PARTS & SERVICE NEWS

REF NO.	AA04028A
DATE	April 20, 2004

SUBJECT: TIRE RUBBING ON BLADDER ACCUMULATORS

PURPOSE: To introduce a kit for relocating accumulators to eliminate tire interference.

FIGURE 1. NEW ACCUMULATOR MOUNTING BRACKET

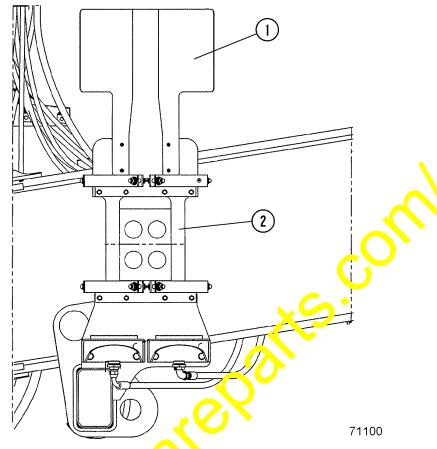
Some trucks in operation may experience slight interference between the left from tire and the rear bladder accumulator mounted on the left frame rail. Accumulator Relocation Kit (XK0307) has been developed to move the accumulator forward (toward the front of the truck) and inward (toward the frame rail). A new mounting bracket (2, Figure 1) allows for the necessary clearances. The new bracket also provides a mount for a heat shield (1) to protect the accumulators from engine exhaust piping. A drawing, Figure 2, containing installation instructions is included in the kit. Lefter to Table 1 for a complete listing of kit components.
